CADDISFLY

PACKAGING: Parts and Assembly

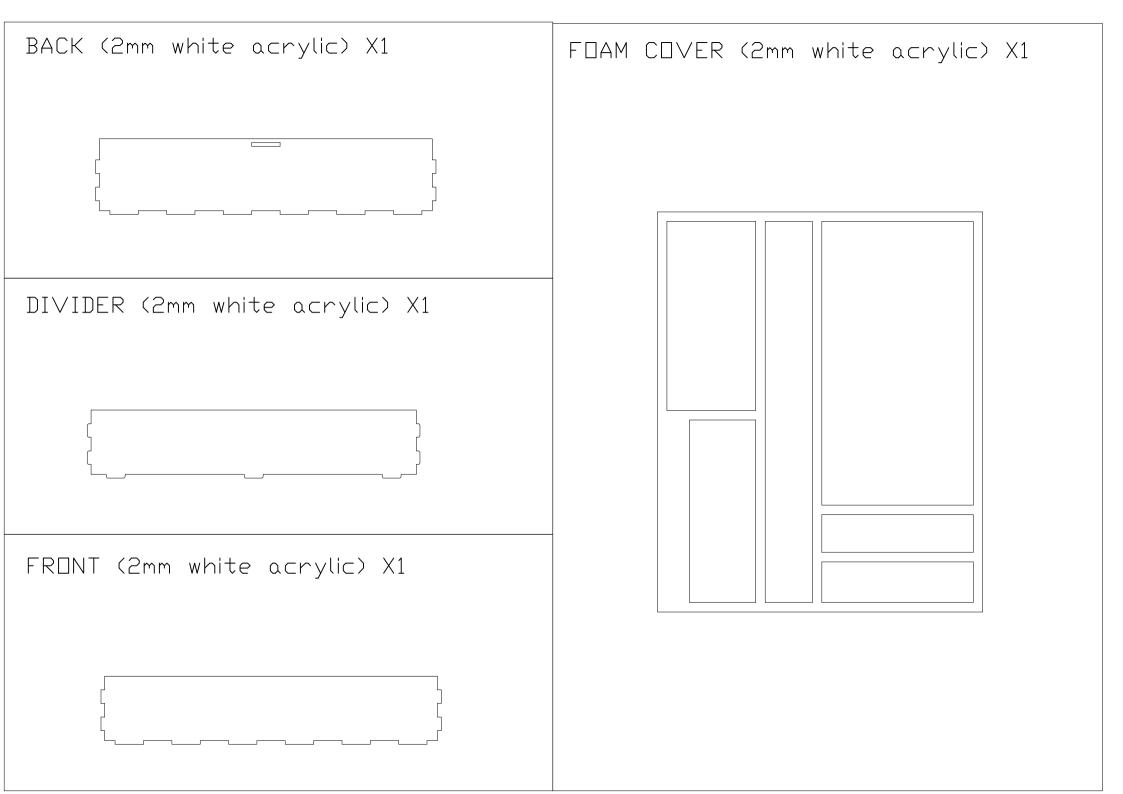
Changed the cover mechanism to a silding, rather than a clasip form, as the acrylic would keep breaking	
Altered layout for better spacing	
	Γ
